Building Inspection Report

Inspection Date: Fri, 23 Jan 2026

Property Address: 4/3-5 Atkinson St, Liverpool NSW 2170,
Australia

Defects 1.01

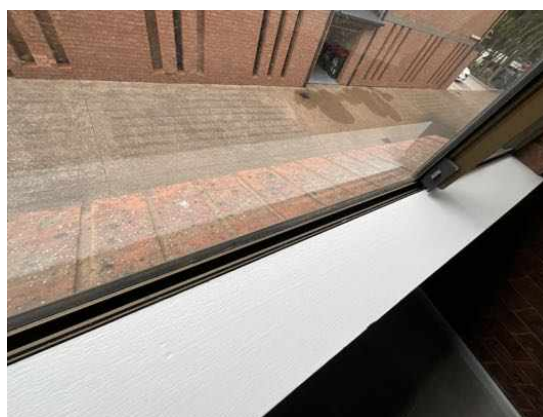
| Finding: | Window child lock missing |
| Information: | The window in question lacks a child lock mechanism, which poses a potential safety risk to young occupants in the premises. As per Australian Standards windows accessible to children should be equipped with appropriate child safety locks to prevent accidental opening, reducing the risk of falls and ensuring compliance with safety regulations. |

Defects 2.01

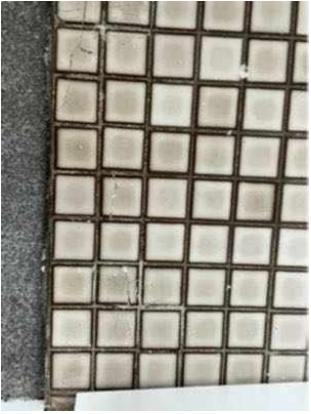
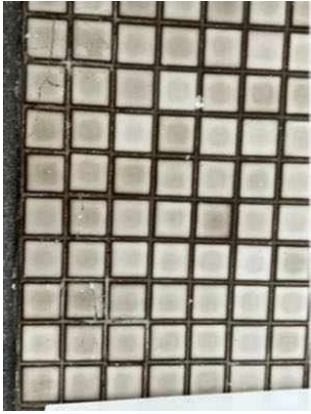
| Finding: | Tiles - Cracked or damaged |
| Information: | Cracking was evident to the tiling in this area at the time of inspection. While the cracking appears to be minor, this area is frequently exposed to water, allowing potential for water penetration into adjoining sections of walls or flooring. |

If left unmanaged, water penetration to these areas may lead to subsequent water damage, which is likely necessitate repair work to affected building elements.

A tiling contractor should be appointed to ensure that no further water damage occurs. The re-application of silicone and grouting throughout remaining tile work is also advised, to further protect the area against water penetration.

Where water penetration has led to water damage, appointment of a relevant tradesperson may be required to repair damaged building elements.

Defects 3.09

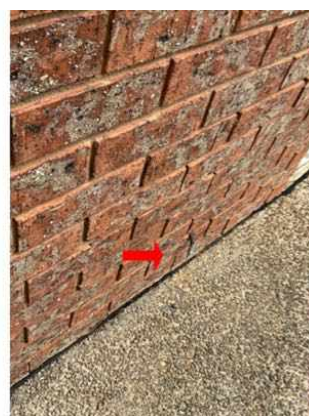
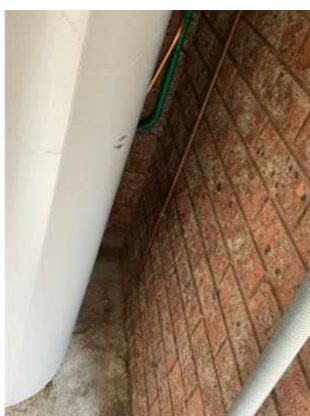
| Finding: | HWS Overflow - Not Connected |
| Information: | The Hot Water System (HWS) overflow was found to be disconnected from storm water drainage and is creating excessive moisture in the surrounding area. |

These damp conditions can lead to secondary defects such as rot, rust or corrosion of associated building elements, the formation of fungal decay, or even the creation of potential slip hazards. When coupled with poor site drainage, pooling of water may also attract termite activity to this area.

It is highly recommended that a licensed plumber be appointed to connect the HWS overflow in order to prevent such an environment from being created. These minor works should be carried out as soon as possible.

Defects 3.10

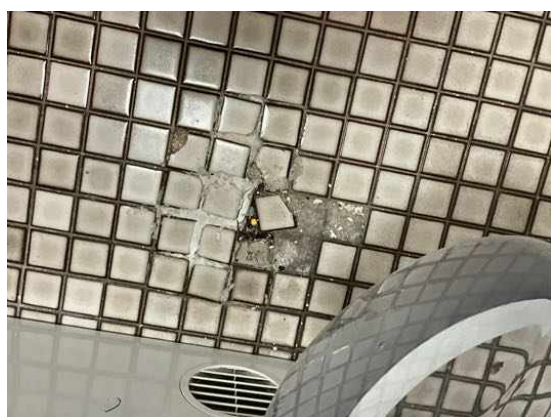
| Finding: | Tiles - Cracked or damaged |
| Information: | Cracking was evident to the tiling in this area at the time of inspection. While the |

cracking appears to be minor, this area is frequently exposed to water, allowing potential for water penetration into adjoining sections of walls or flooring.

If left unmanaged, water penetration to these areas may lead to subsequent water damage, which is likely necessitate repair work to affected building elements.

A tiling contractor should be appointed to ensure that no further water damage occurs. The re-application of silicone and grouting throughout remaining tile work is also advised, to further protect the area against water penetration.

Where water penetration has led to water damage, appointment of a relevant tradesperson may be required to repair damaged building elements.

Defects 3.11

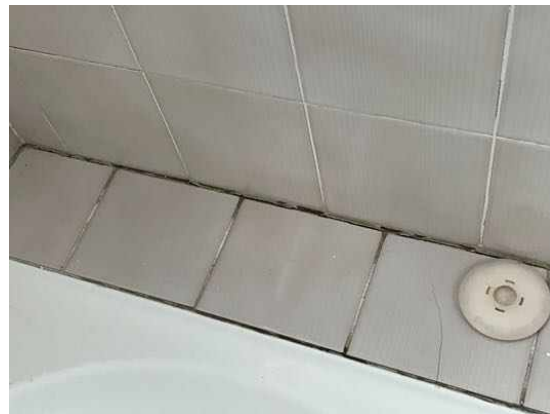
| Finding: | Sealant and grouting - Missing or damaged |
| Information: | It was noted on inspection that sealant or grout is degraded to the tiled shower alcove and or other areas of the bathroom. |

There appears to be excessive mould to the sealant and grout which will likely require scraping out and replacement.

Flexible and mould resistant materials should be applied to affected areas to prevent any subsequent water damage that is likely to occur. Regular maintenance and replacement of damage or missing or damaged sealant and grout is highly recommended to the wet areas, as this is a regular wear and tear defect. Sealant and grouting in areas that come into regular contact with water should be maintained for the long term care of your property.

A sealant specialist or tiling contractor should be appointed to complete these works as soon as possible

Defects 3.15

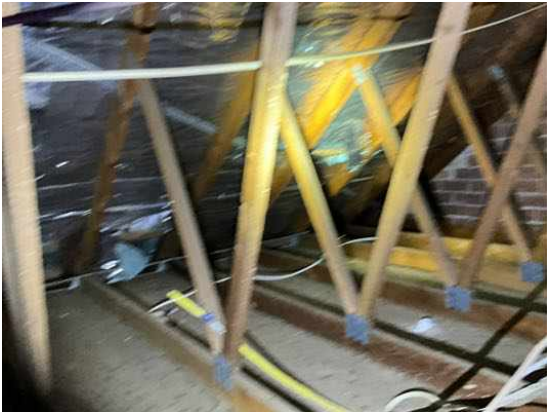
| Finding: | Insulation - Missing |
| Information: | Upon inspection of the roof void it was noted that insulation is not present. |

Insufficient insulation will result in a comparatively higher cost to heat and cool a property as there is a lack of Insulation (or uneven coverage of insulation) which works as a barrier to heat transfer. This helps to keep out unwanted heat in summer and preserves warmth inside your home in winter. It can also help soundproof your home from unwanted airborne noise transfer.

Where insulation is absent, the area does not meet current Australian Standards. Installation of adequate insulation is required and should be conducted as soon as possible.
